UNITED STATES PATENT AND TRADEMARK OFFICE

Office Action Summary	Application No. 10/585,394	Applicant(s) PRENTNER ET AL.	
	Examiner MATTHEW W. ING	Art Unit 3637

DETAILED ACTION

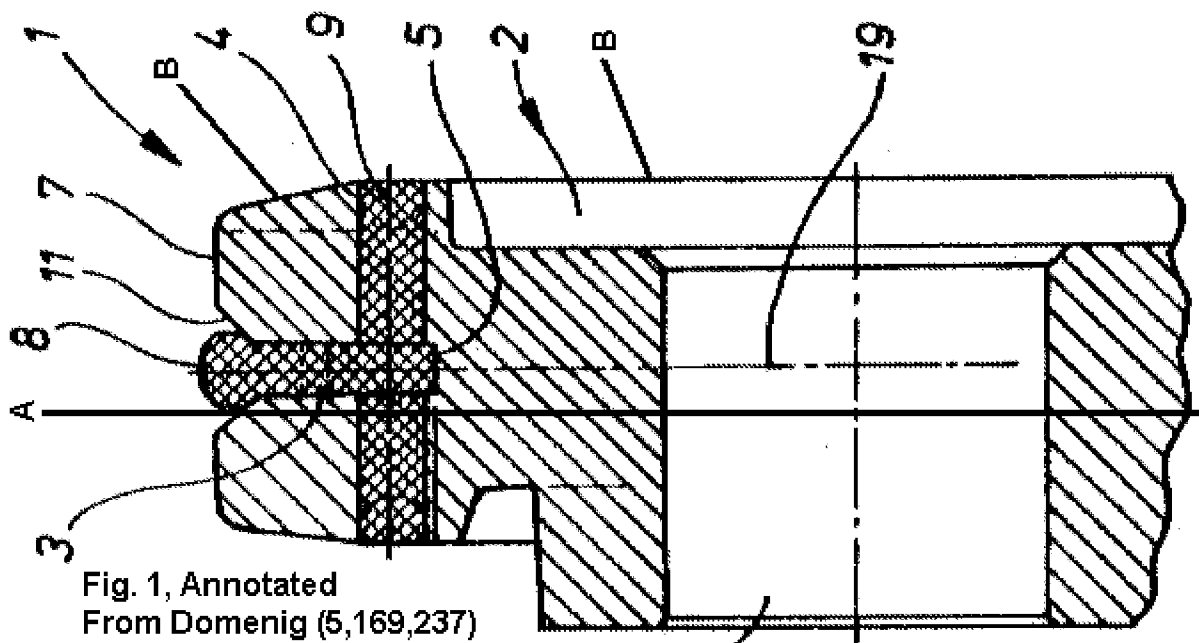
the pull-out rail, during pulling-out and pushing-in operations of the drawer; and control roller (18) mounted rotatably about an axis on the central rail and in engagement with the carcass rail and with the pull-out rail; wherein the control roller mounted rotatably on the central rail serves exclusively for synchronizing a position and movement of the central rail with the pulling-out and pushing-in operations of the drawer. See col. 1 lines 6-8 & 38-39 (describing the roller of Sekerich as a "progressive roller" for "caus[ing] progressive movement of the rails"). Since the carcass rail (16) and pull-out rail (12) are mounted to cabinet and drawer, respectively, it follows that the load imposed by said drawer is carried by said carcass rail via said central & pull-out rails; and that, therefore, said control roller does not serve as a load-bearing device. This is further suggested by the fact that the control roller of Sekerich is easily replaceable without disassembly of said rails or removal of said drawer (col. 5, lines 10-23). Additionally, Domenig teaches a roller (1) comprising a bearing part including a hard body (7) and a soft body (8), wherein the soft body at least in part projects in a radial direction relative to the hard body (Fig. 1), and the soft body extends over an axial extent less than an axial extent over which the hard body engages with the carcass rail and with the pull-out rail (Fig. 1).

5. Regarding claim 1, Domenig teaches a soft body (8) arranged in a region (i.e., portion of 1 to the right of line A in Fig. 1 Annotated) of an axial end side (B) of the roller (1). The examiner also notes that even assuming, *arguendo*, that the soft body of Domenig cannot be said to be arranged in the region of an axial end side of the roller, mere rearrangement of the essential working parts of a device has been held to involve only routine skill in the art (see MPEP 2144.04(VI)(C)). Since the instant application fails to recite any specific utility associated with the soft body's location, it therefore would have been obvious to one of ordinary skill in the art to
